42 HONEYSUCKLE DRIVE COTTAGE CREEK PRECINCT NEWCASTLE

NEWCASTLE CITY COUNCIL
DEVELOPMENT APPLICATION

ARCHITECTURAL DESIGN STATEMENT

SUMMARY OF PROPOSED AMENDMENTS

0.1 DESIGN CHANGES GROUND FLOOR

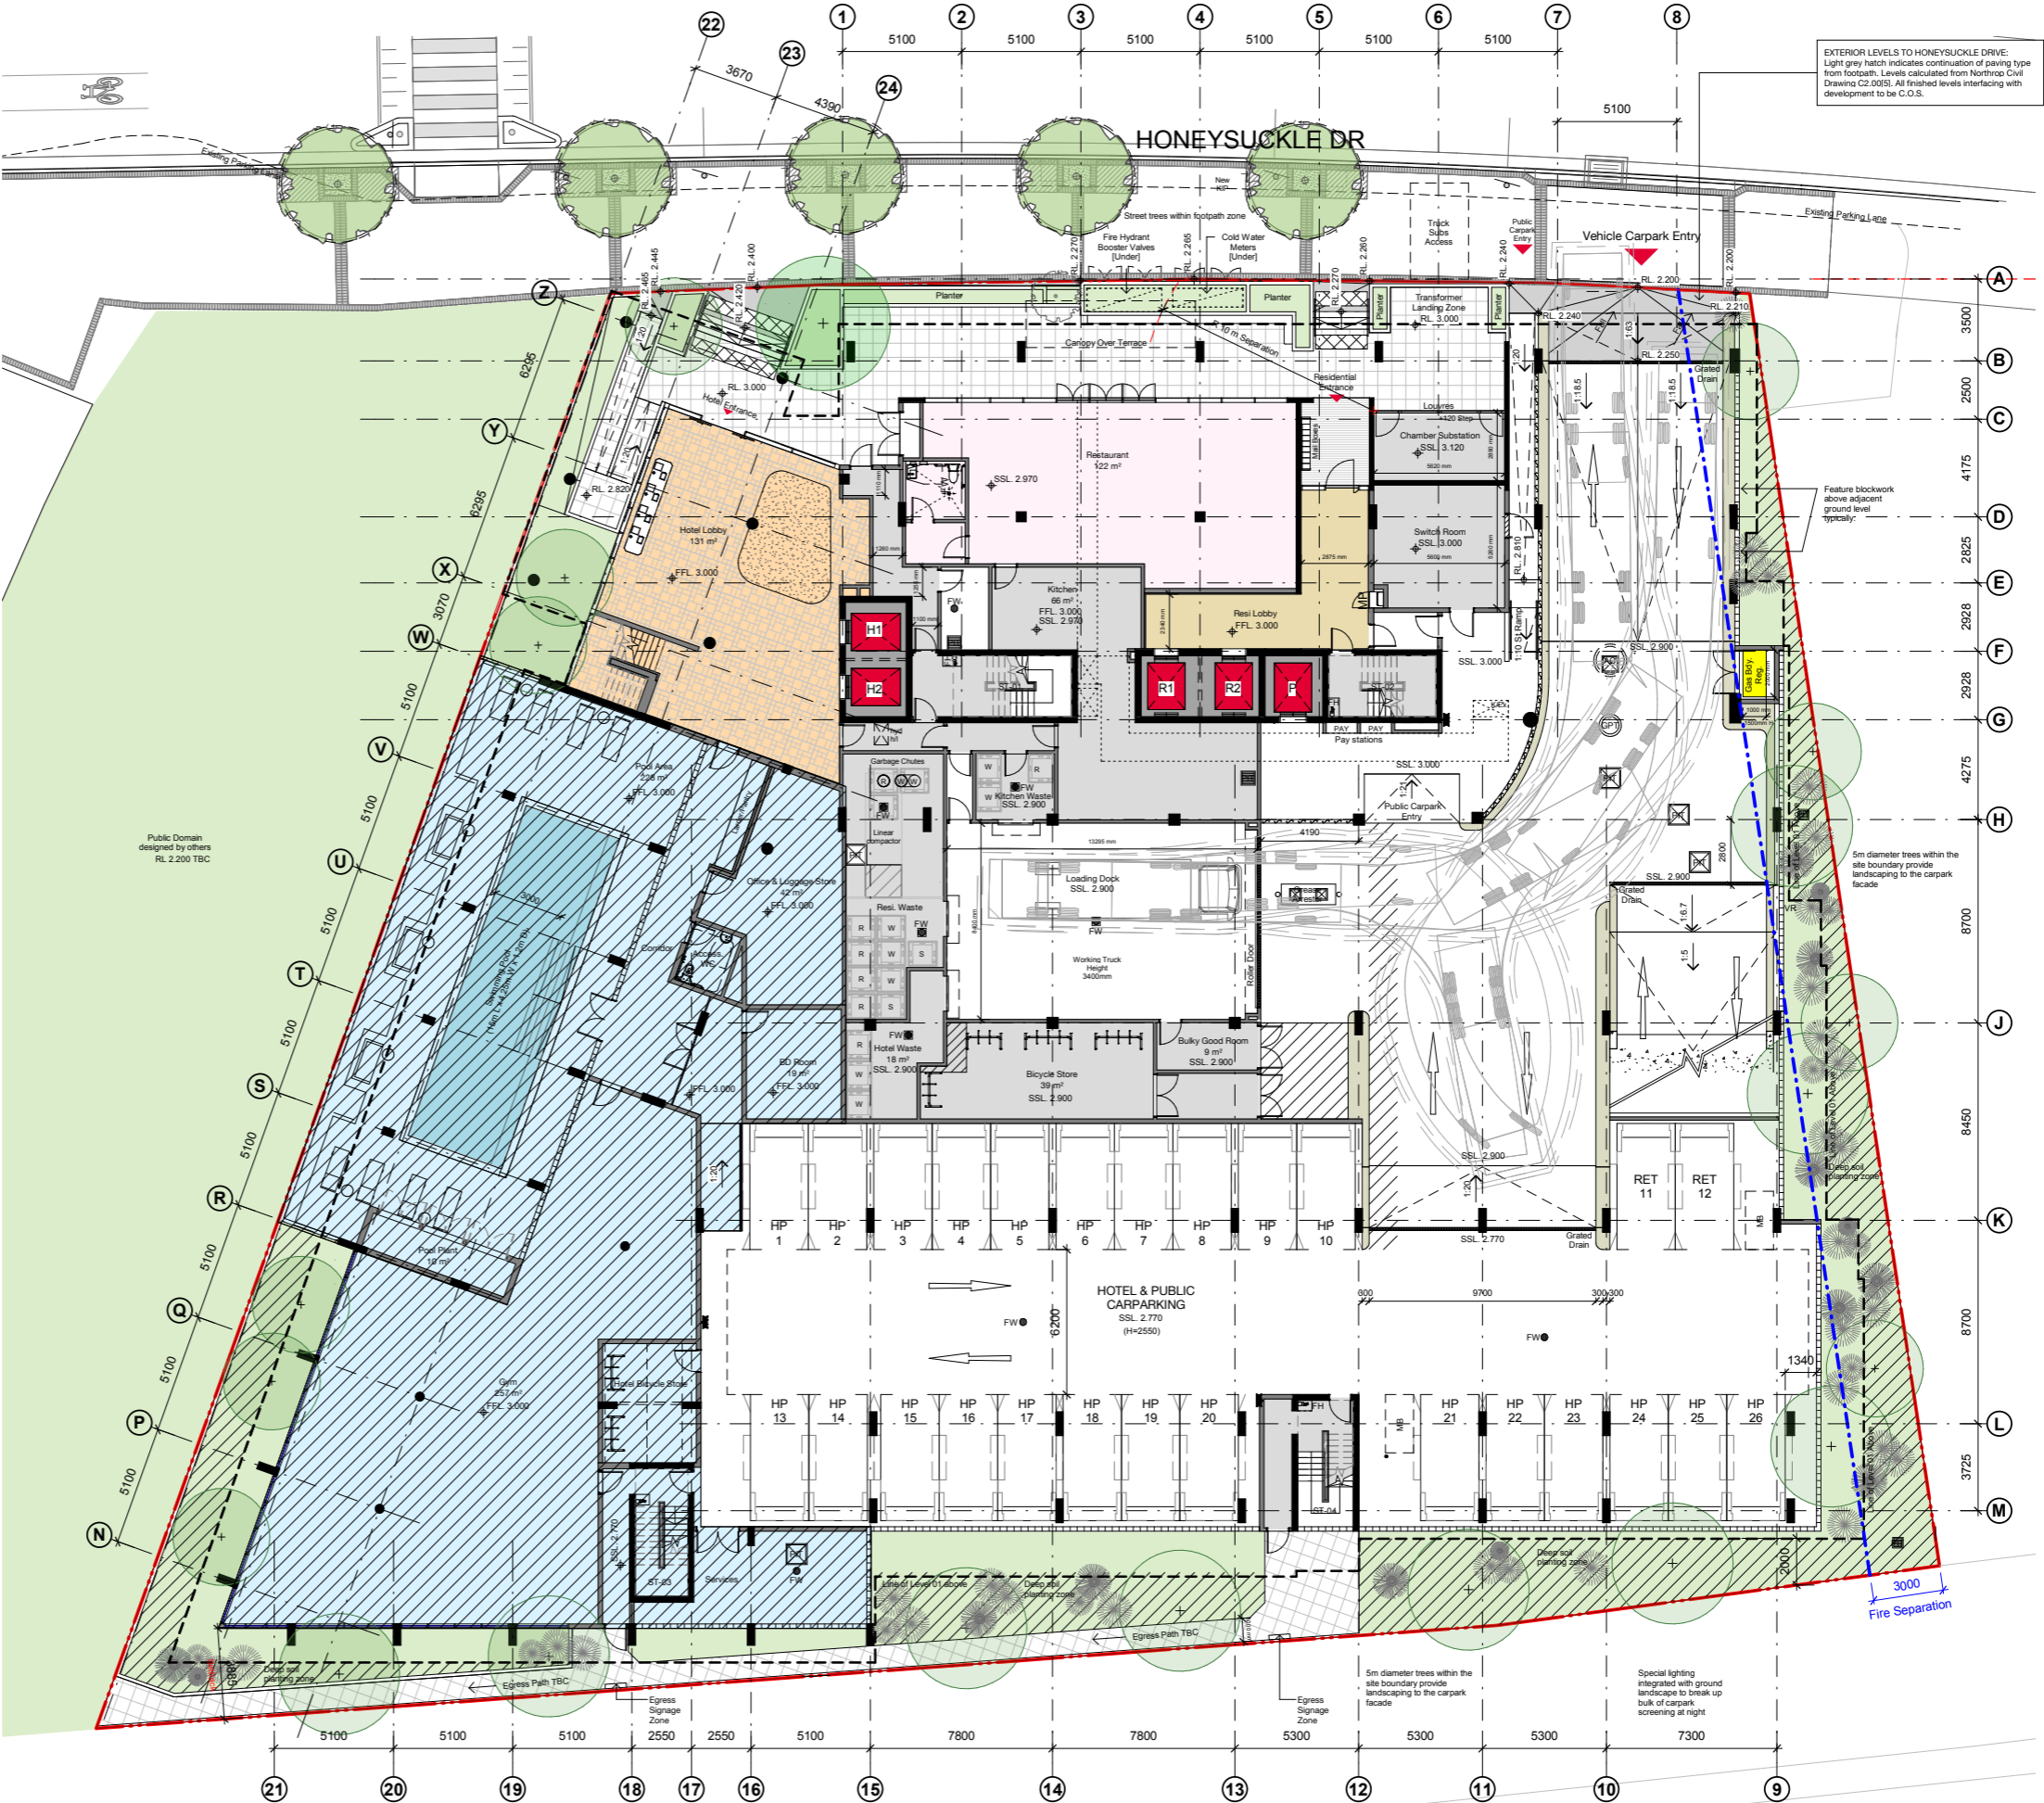
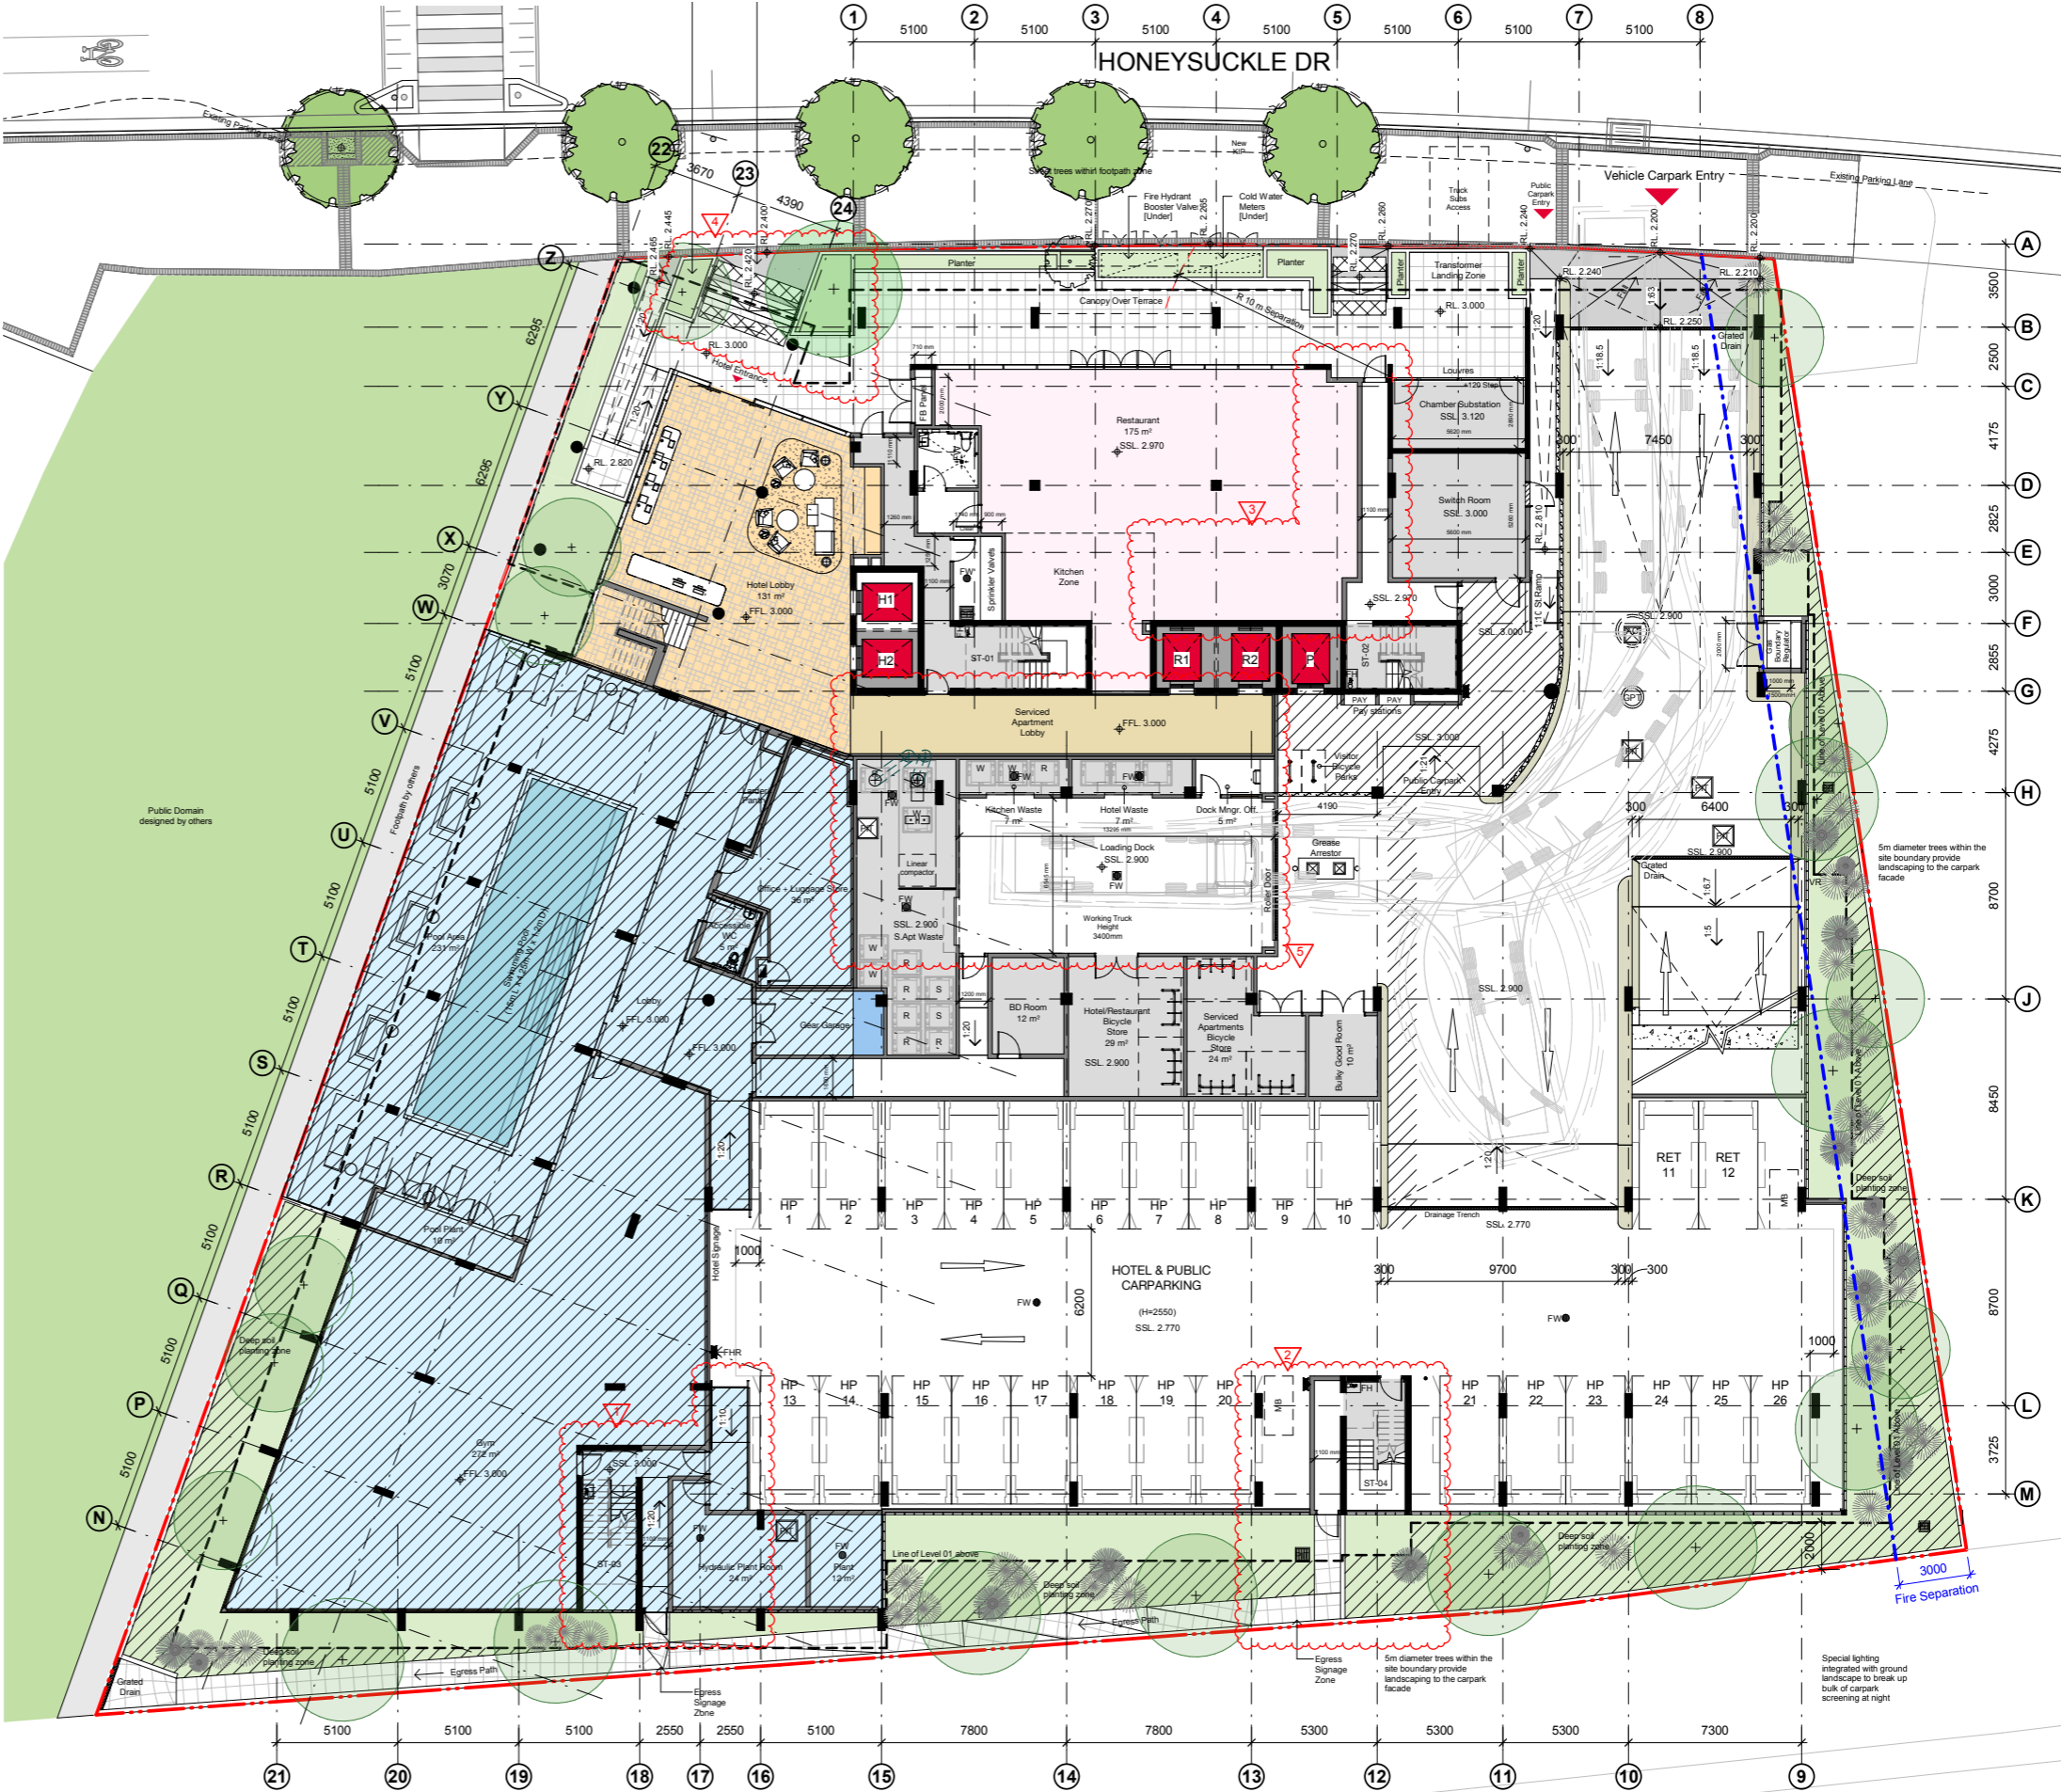
- 1 / Adjustments to the location of the south western fire stair. To accommodate the revised serviced apartment floorplate, the fire stair shifts to the west by one hotel bay. Facade treatment from Ground to Level 04 are adjusted to suit.
- 2 / Adjustments to the location of the south eastern fire stair. To accommodate the revised serviced apartment floorplate, the fire stair shifts to the east. Facade treatment from Ground to Level 05 Parking are adjusted to suit.
- 3 / Deletion of the residential building entrance with floorspace incorporated into the restaurant tenancy.
- 4 / Addition of signage zones to the external building facade.
- 5/ Addition of serviced apartment lift lobby at Ground Floor, accessed via the main hotel lobby. BOH and loading dock area revised as required.

1.1 DESIGN CHANGES FIRST FLOOR

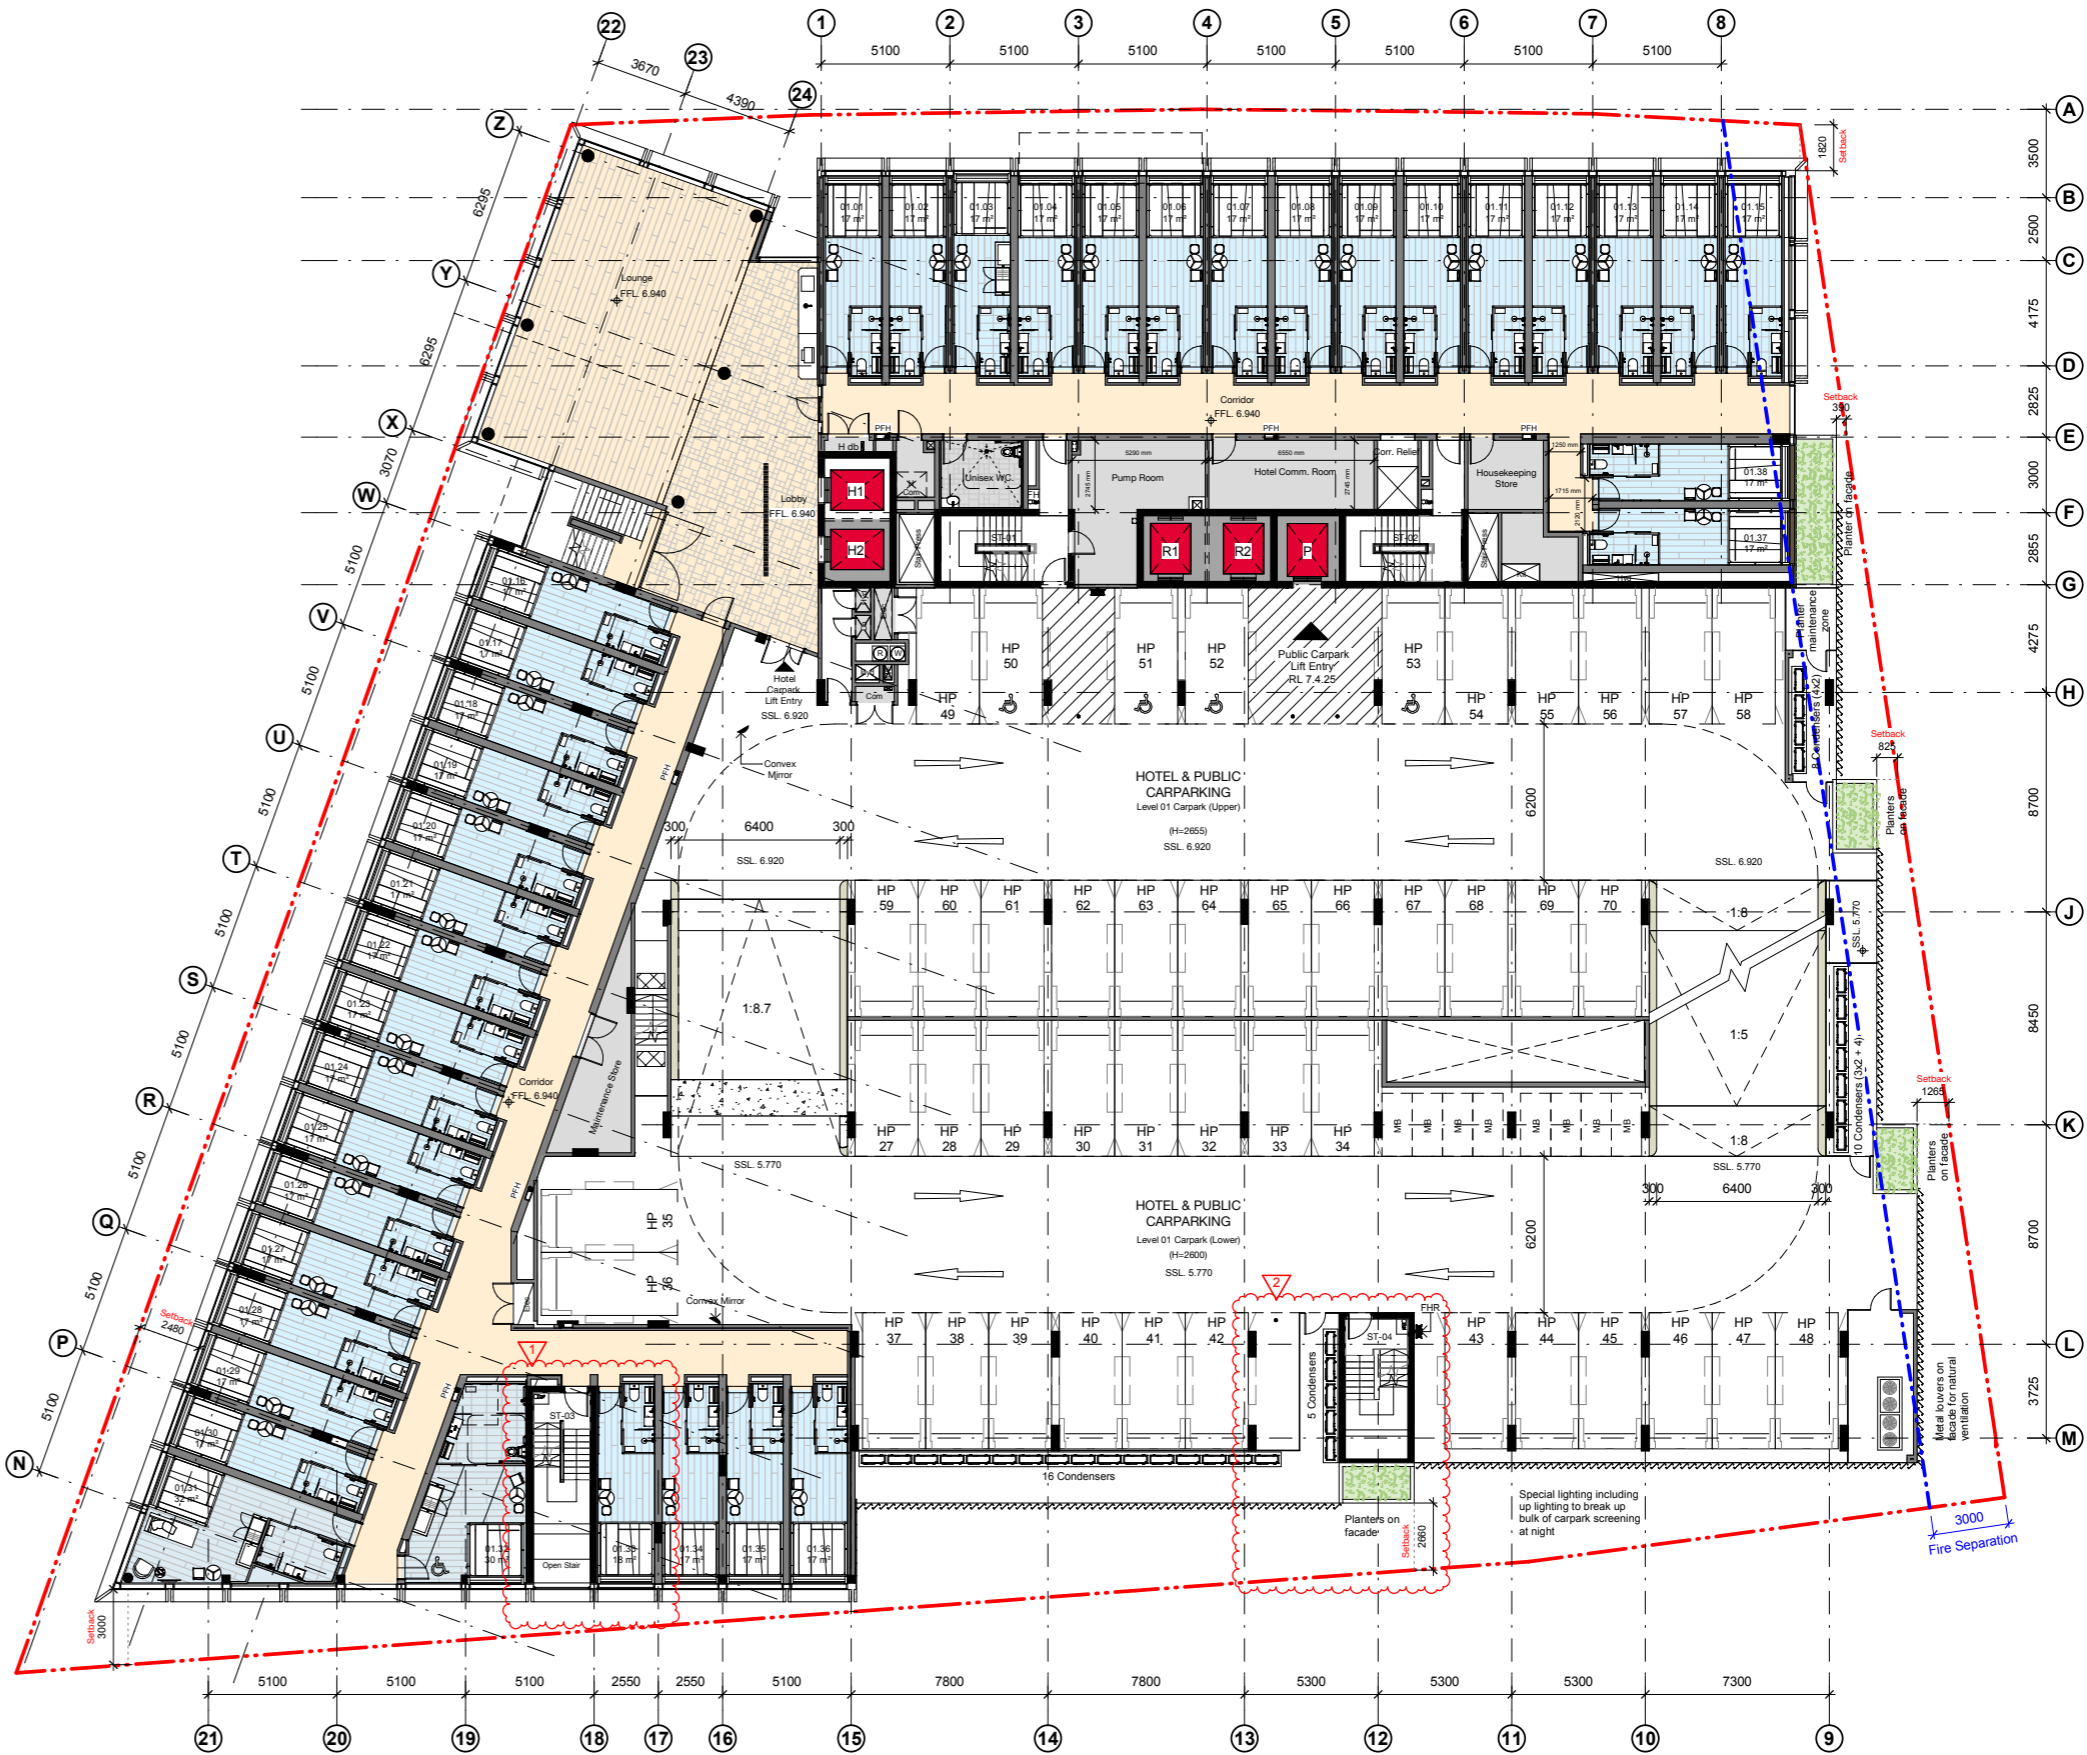
- 1 / Adjustments to the location of the south western fire stair. To accommodate the revised serviced apartment floorplate, the fire stair shifts to the west by one hotel bay. Facade treatment from Ground to Level 04 are adjusted to suit.
- 2 / Adjustments to the location of the south eastern fire stair. To accommodate the revised serviced apartment floorplate, the fire stair shifts to the east. Facade treatment from Ground to Level 05 Parking are adjusted to suit.
